E C O L O G I C A L R E V I E W

North Lake Mechant Landbridge Restoration, Construction Unit 2
CWPPRA Priority Project List 10
State No. TE-44

August 26, 2004

This document reflects the project design as of the 95% Design Review meeting, incorporates all comments and recommendations received following the meeting, and is current as of August 26, 2004.

Figure 5. Estimated elevation change of the created marsh over the 32 years

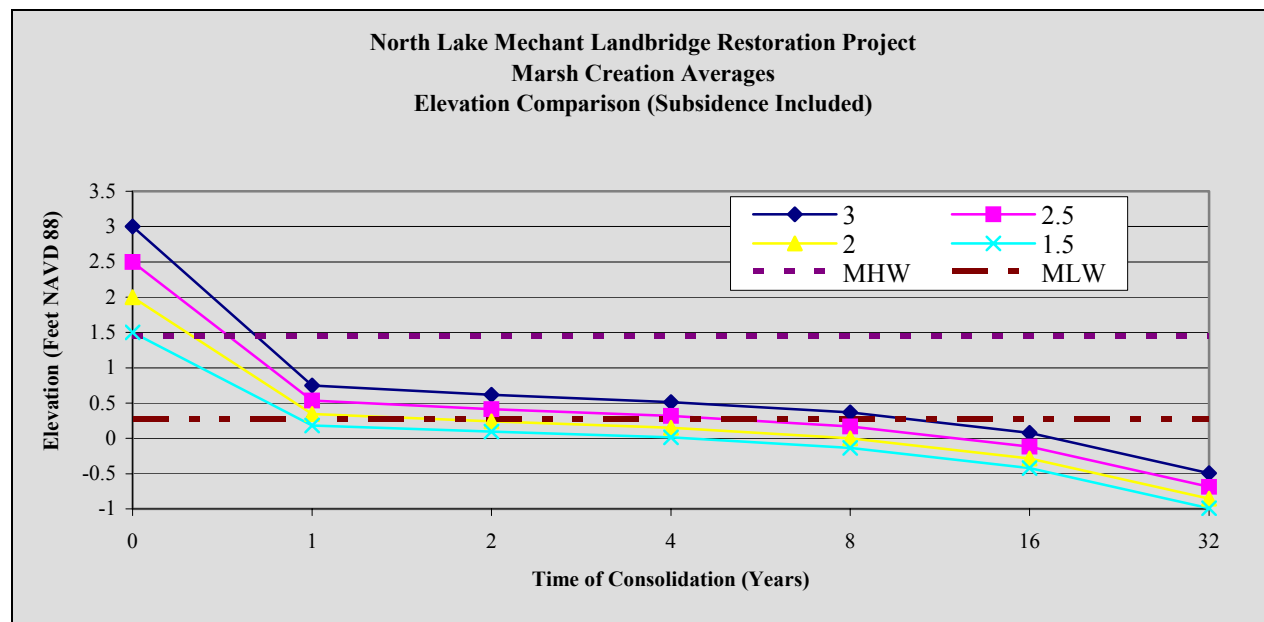
brought on by settlement, shrinkage, and dewatering of the dredged material, as well as through a high rate of subsidence, estimated at 0.42 inches per year (Penland and Ramsey 1990). According to the geotechnical investigation (Soil Testing Engineers, Inc. 2002), it is expected that these factors will lead to the created marsh reaching the intertidal range by year 1 (mean low water is 0.27 feet NAVD-88 and mean high water is 1.45 feet NAVD-88) (Figure 5). The created marsh platform will remain in the intertidal range until approximately year 10, at which point according to the geotechnical report, the marsh platform will cease to be emergent (Table 1; Figure 5).

A review of the results from the restoration projects referenced above demonstrates the importance of identifying the optimal dredge material elevation for the establishment of marsh vegetation and the importance in achieving that targeted elevation. The results of the geotechnical investigation can then be utilized to forecast and predict the rate of settlement of the dredged material to further refine that target elevation. In view of the predicted high rate of settlement and historical high rate of subsidence in the North Lake Mechant Landbridge Restoration project area, the created marsh design includes placement of the dredged material at an elevation of 3.0 feet NAVD-88. As currently designed, and according to the geotechnical investigation (STE, Inc. 2002), it is expected that the created marsh will reach the intertidal range (0.27 to 1.45 feet NAVD-88) one year post construction (Figure 5), and continue to subside over time, eventually projected to subside below mean low water elevation sometime around year 10. By using the geotechnical investigation to predict the settlement of the dredged material, by phasing the construction in two lifts, and by using a small dredge, the LDNR project team feels that it is likely that this is the optimum achievable result considering the soft nature of the existing soil. However, some consideration should be given to the possibility of returning during the maintenance phase, to allow fine-tuning of the final elevation (Raynie and Visser 2002).

- This project would benefit greatly from an Operations and Maintenance plan that would include a scheduled marsh nourishment event, to maintain marsh elevation in the desired range throughout the project life.
